SUNDRY NOTICES AND REPORTS ON WELLS

abandoned w	N/A				
SUBMIT IN TR	7 If Unit or CA/Agreement, Name and/or No N/A 8 Well Name and No				
l Type of Well Oil Well□□□					
2 Name of Operator Murchison C	Puma Federal Com #5H 9 API Well No				
3a Address 1100 Mira Vista Blvd, Plano, 7	3b Phone No (include area code) 972-931-0700		30-015-40633		
4 Location of Well (Footage, Sec.	10 Field and Pool, or Exploratory Area Empire; Glorietta-Yeso				
Sec. 14, T17S, R28E, Lot H, 2	260' FNL & 150'FEL			County or Parish, State Eddy

Puma Federal Com 2H 30-015-40633 Murchison Oil and Gas September 28, 2012 Conditions of Approval

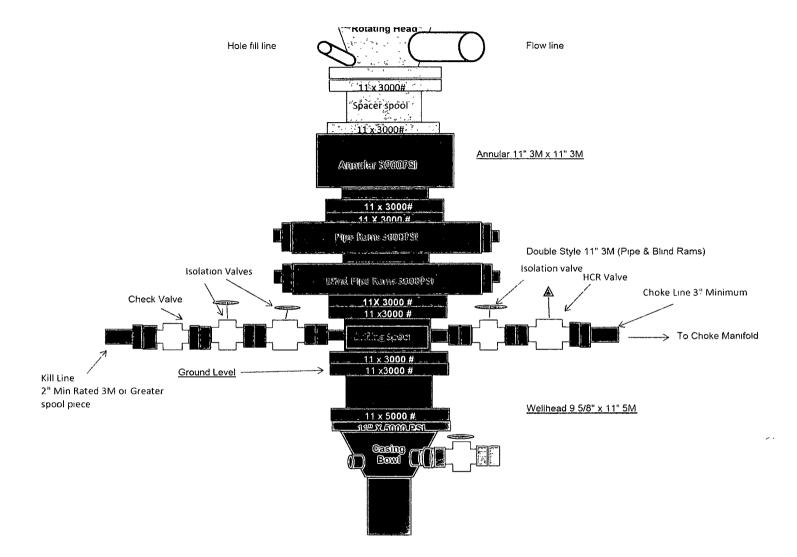
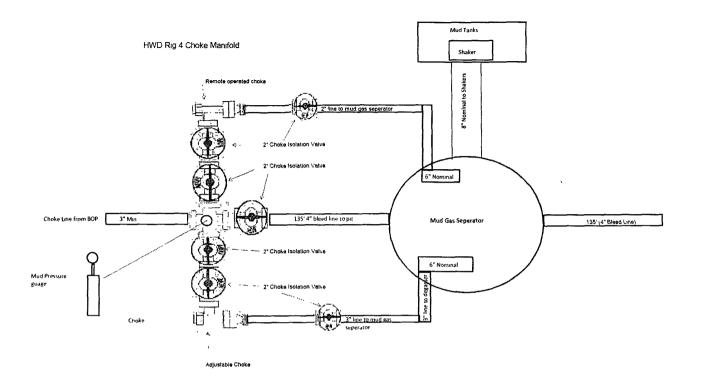
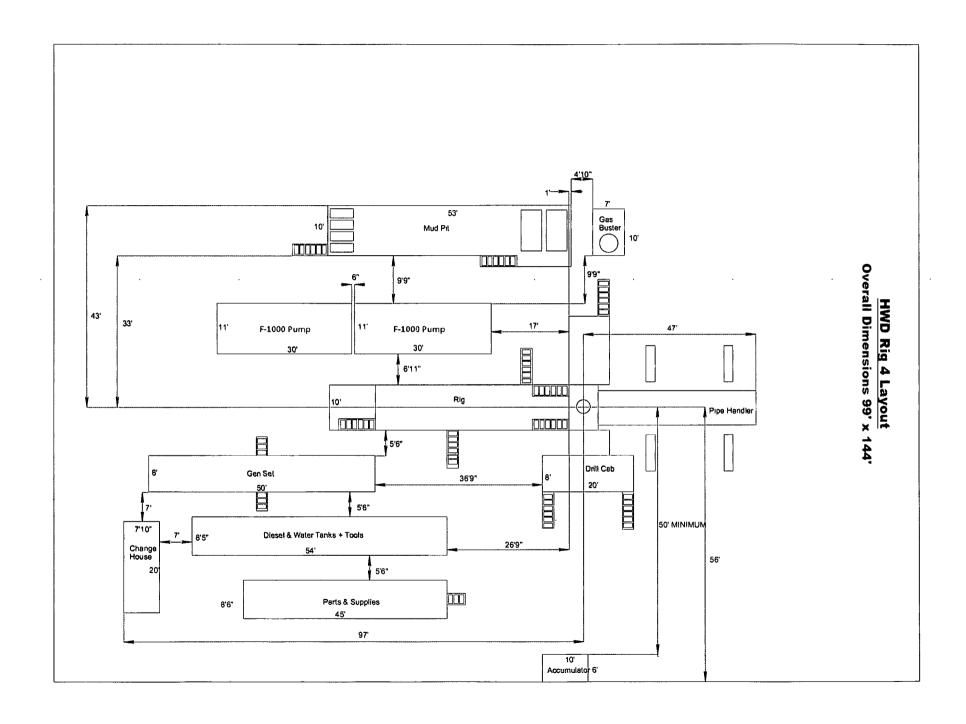
As well we request to change the choke manifold, BOP stack, and rig layout. See attached schematics.

- 2. BOP and choke manifold approved as presented.
- 3. Rig layout approved as long as no additional surface disturbance occurred due to the change.
- 4. Variance approved to use flex line from BOP to choke manifold. Check condition of flexible line from BOP to choke manifold, replace if exterior is damaged or if line fails test. Line to be as straight as possible with no hard bends and is to be anchored according to Manufacturer's requirements (i.e. operator shall install Midwest Hose & Specialty, Inc. approved hose safety clamp on the mid-section of the hose and connect to the sub-floor). The flexible hose can be exchanged with a hose of equal size and equal or greater pressure rating. Anchor requirements, specification sheet and hydrostation pressure test certification matching the hose in service, to be onsite for review. If the BLM inspector questions the straightness of the hose, a BLM engineer will be contacted and will review in the field or via picture supplied by inspector to determine if changes are required (operator shall expect delays if this occurs).

Internal Hydrostatic Test Graph

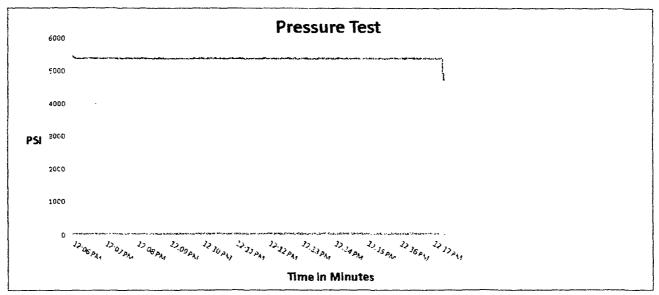
We request to use a coflex hose to go from the BOP stack to the Choke Manifold. See attached Hydrotest, and anchor requirements.
